UNITED STATES PATENT AND TRADEMARK OFFICE

APPLICATION NO.	FILING DATE	FIRST NAMED INVENTOR	ATTORNEY DOCKET NO.	CONFIRMATION NO.
10/808,011	03/24/2004	Takeshi Tsuji	FP04-015US	5690
1218	7590	12/02/2004	EXAMINER	
CASELLA & HESPOS 274 MADISON AVENUE NEW YORK, NY 10016			HARVEY, JAMES R	
			ART UNIT	PAPER NUMBER
			2833

Office Action Summary

DETAILED ACTION

Fig. 4.

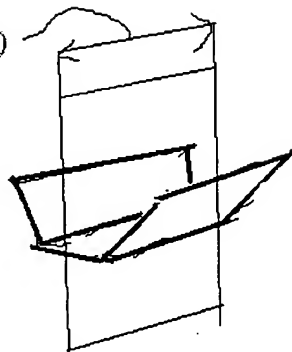
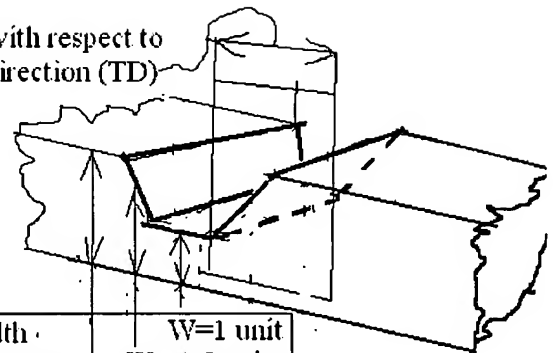
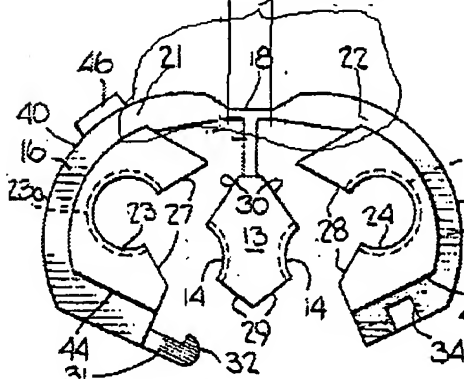
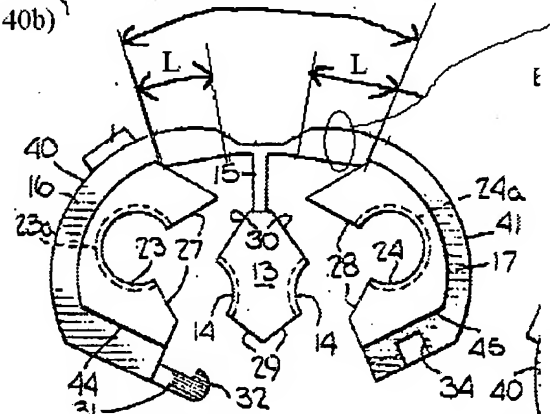
-- In reference to Claim(s) 1 and 9, Crimmins shows (figures 3 and 4)

a flexible hinge (see examiner's figure) with a first end (see examiner's figure) coupled to the main body (16) and an opposite second end (see examiner's figure) coupled to the lid (17), the flexible hinge having a weakened portion (see examiner's figure), the weakened portion being formed in a set region (see examiner's figure) with outer ends (see examiner's figure) at positions spaced in towards a middle part of the flexible hinge from the opposite ends by a specified distance (see examiner's figure).

-- In reference to Claim(s) 4 and 13, Crimmins shows the weakened portion (see examiner's figure) is substantially symmetrical with respect to a longitudinal direction (LD) and transverse direction (TD) of the flexible hinge.

-- In reference to Claim(s) 5 and 14, Crimmins shows widened portions (see examiner's figure) and a width of the flexible hinge (40) along a transverse direction (TD) is widened gradually towards the opposite ends (40a, 40b).

-- In reference to Claim(s) 6 and 15, Crimmins shows the widened portions (WD) are provided completely within the specified distance (L; L').

-- In reference to Claim(s) 7, Crimmins shows (see examiner's figure; widened portion) the flexible hinge has a substantially constant thickness at all locations spaced from the weakened portion (see examiner's figure). The spacing is seen to be at the transition area where the width changes from 1 unit to 2 units and results in the widened portion (2 units wide) being spaced from the weakened portion (1 unit wide).

symmetrical with respect to
a longitudinal direction (LD)

symmetrical with respect to
a transverse direction (TD)

a width
is widened
gradually

W=1 unit
W=1.5 units
W=2 units

outer ends (Pa, Pb)
of the set region (R)

first end (40a) / second end
opposite ends (40a, 40b)

weakened portion (41)
slit (41)
along
region (R)

hinge (40)

Longitudinal extension (LE)

widened portions (40W)
